RENESAS TECHNICAL UPDATE

Product Category	MPU/MCU		Document No.	TN-SH7-A883A/E	Rev.	1.00
Title	Correction of errors regarding the SRAM Interface on Internal Bus of the Bus State Controller (BSC)		Information Category	Technical Notification		
Applicable Product	• SH7214 Group • SH7216 Group	Lot No. All lots	Reference Document	• SH7214 Group, SH7216 Group User's Manual: Hardware Rev.4.00 (R01UH0230EJ0400)

Figure 9.41 Example of Connection with 16-Bit Data-Width SRAM with Byte Selection

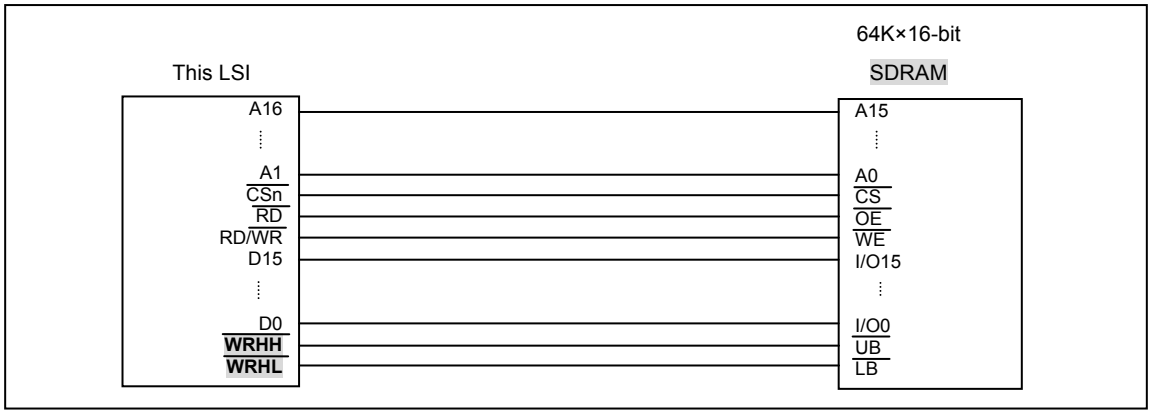
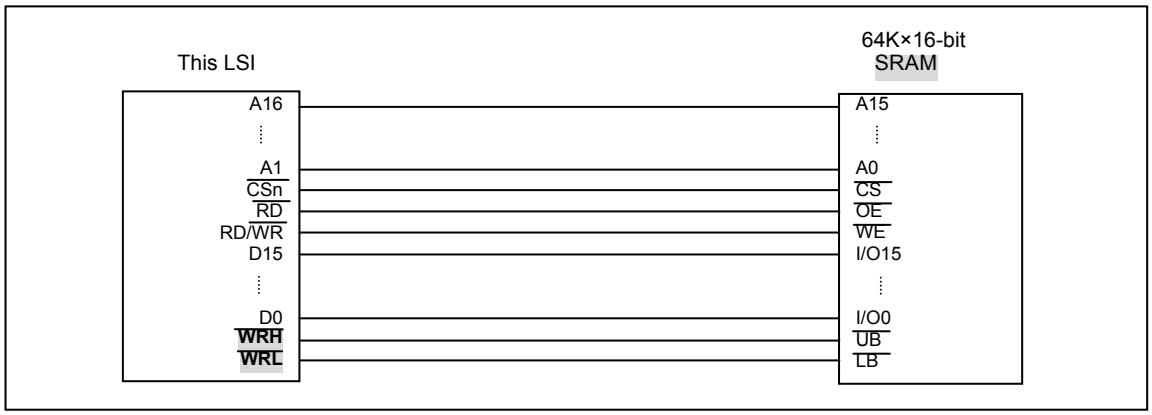
9.5.8 SRAM Interface with Byte Selection

Erroneous:

Corrected:
